BEAUREGARD SMALL AREA PLAN COMPILED COMMUNITY COMMENTS

4-17-2012

Figure 7: Plan Area Boundary

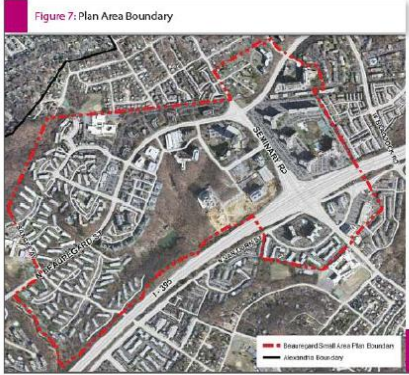
*p. 4, figure 7: Note that the plan boundaries do not include the area on the NW corner of Sanger and Beauregard.

Figure 8: Redevelopment Sites

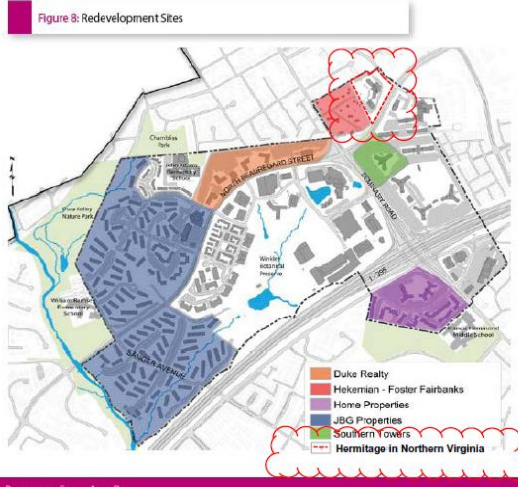
The Hermitage in Northern Virginia property is identified on Figure 8 as a potential redevelopment site. It is currently planned for high density residential use. As an option, the property may be redeveloped with a mix of uses. Redevelopment of the Hermitage property shall not exceed 1.25 FAR. The Hermitage is an important property within Beauregard and its redevelopment would help further the neighborhood street framework, significantly improve the pedestrian environment and streetscape and, together with the Hekemian and Southern Towers neighborhoods, create an important gateway into the Corridor.
